Thoroughfare Committee Meeting

CPC Thoroughfare Committee Meeting Agenda

1. Approve prior Meeting Minutes, February 5, 2026
2. Crouch Road Thoroughfare Plan Amendment
Amendment to the City of Dallas Thoroughfare Plan to change the designation of Crouch Road between Patrol Way and Lancaster Road from a standard two-lane undivided roadway in 56 feet of right-of-way (S-2-U) to a minimum four-lane undivided roadway in 60 feet of right-of-way(M-4-U).

3. Colonial Avenue Thoroughfare Plan Amendment
Amendment to the City of Dallas Thoroughfare Plan to remove Colonial Avenue between Pennsylvania Avenue and Martin Luther King Jr. Boulevard.

Thoroughfare Plan Amendment Map

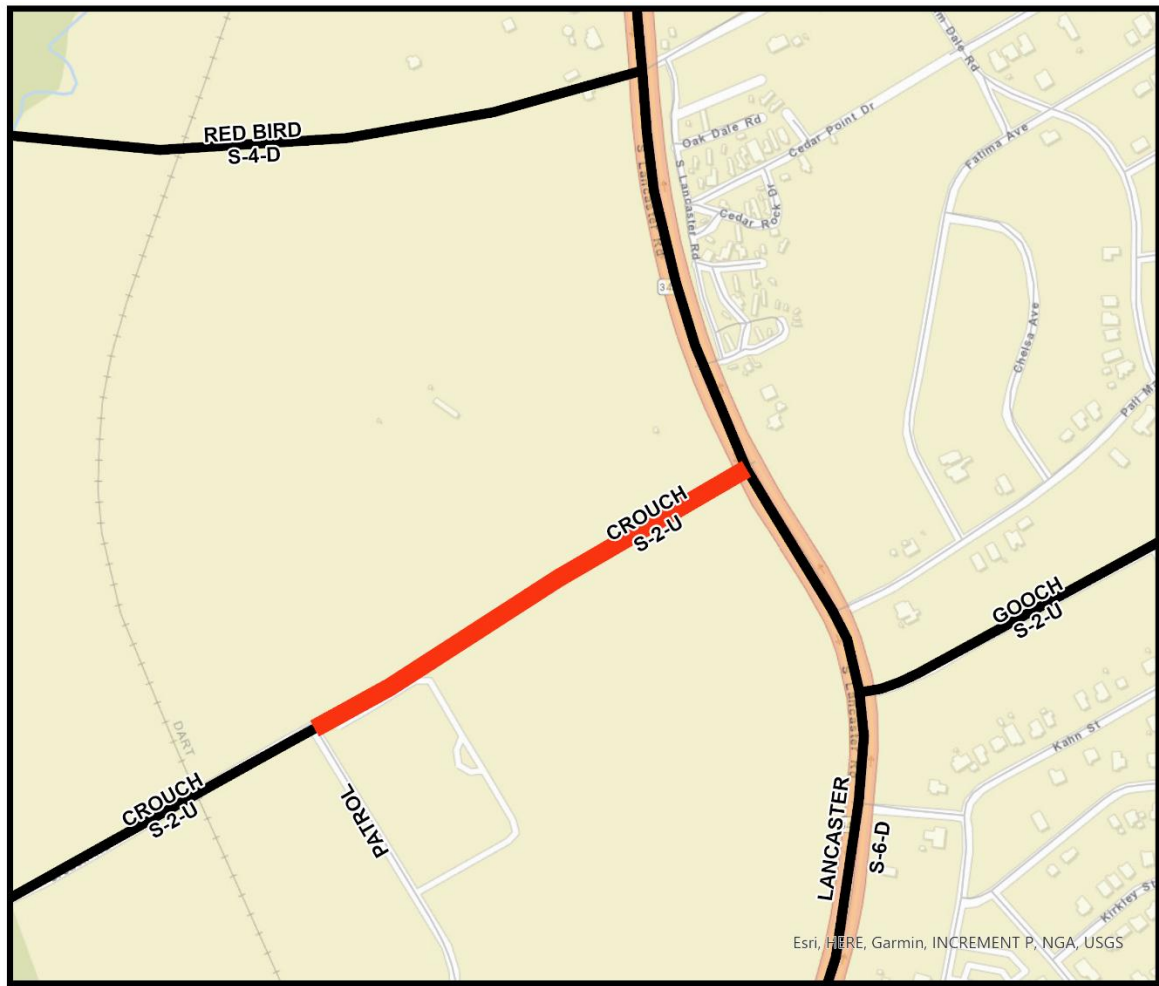
REQUEST: Amendment to the City of Dallas Thoroughfare Plan to (change the designation of Crouch Road between Patrol Way and Lancaster Road from a standard two-lane undivided roadway in 56 feet of right-of-way and 36 feet of pavement (S-2-U) to a minimum four-lane undivided roadway in 60 feet of right-of-way and 40 feet of pavement (M-4-U).

Crouch Cross-Sections

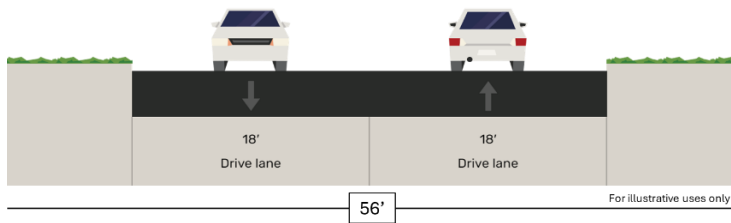
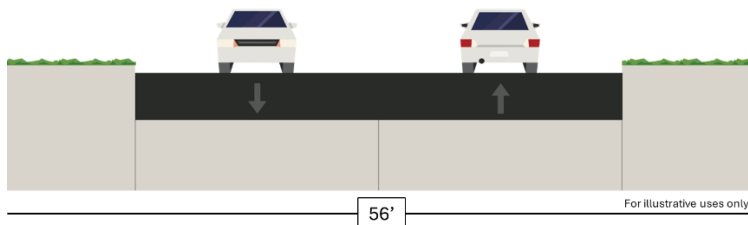
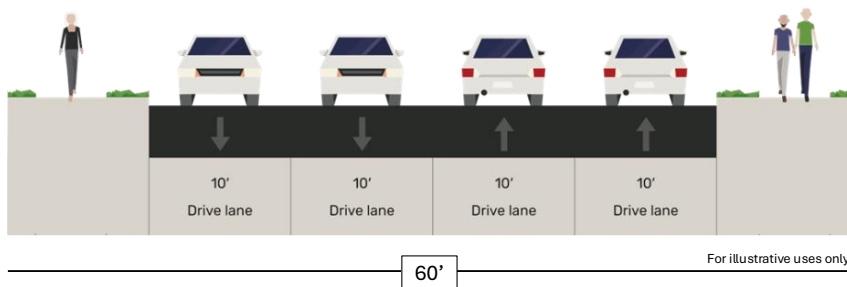
Amendment to the City of Dallas Thoroughfare Plan to change the designation of Crouch Road between Patrol Way and Lancaster Road from a standard two-lane undivided roadway in 56 feet of right-of-way and 36 feet of pavement (S-2-U) to a minimum four-lane undivided roadway in 60 feet of right-of-way and 40 feet of pavement (M-4-U).

The requested amendment is associated with a City-funded street reconstruction project on Crouch Road between Old Ox Road and Lancaster Road as part of the 2017 Bond Program. The project proposes widening the segment between Patrol Way and Lancaster Road from two lanes to four lanes to accommodate the growing residential development at Crouch Rd between Patrol Way and Lancaster Road. The proposed roadway section will include two 10-foot travel lanes in each direction, as well as dedicated turn lanes at intersections.

- The street construction project will change the existing two-lane section of Crouch Road between Patrol Way and Lancaster Road to a four-lane section with two travel lanes in each direction.

Proposed Thoroughfare Plan Designation - Minimum 4-lane undivided roadway in 60 feet of right-of-way and 40 feet of pavement (M-4-U)

Thoroughfare Plan Amendment Map

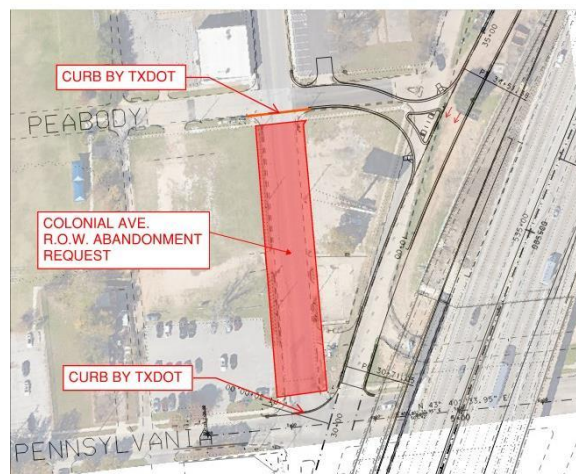
REQUEST: Amendment to the City of Dallas Thoroughfare Plan to remove Colonial Avenue between Pennsylvania Avenue and Martin Luther King Jr. Boulevard.
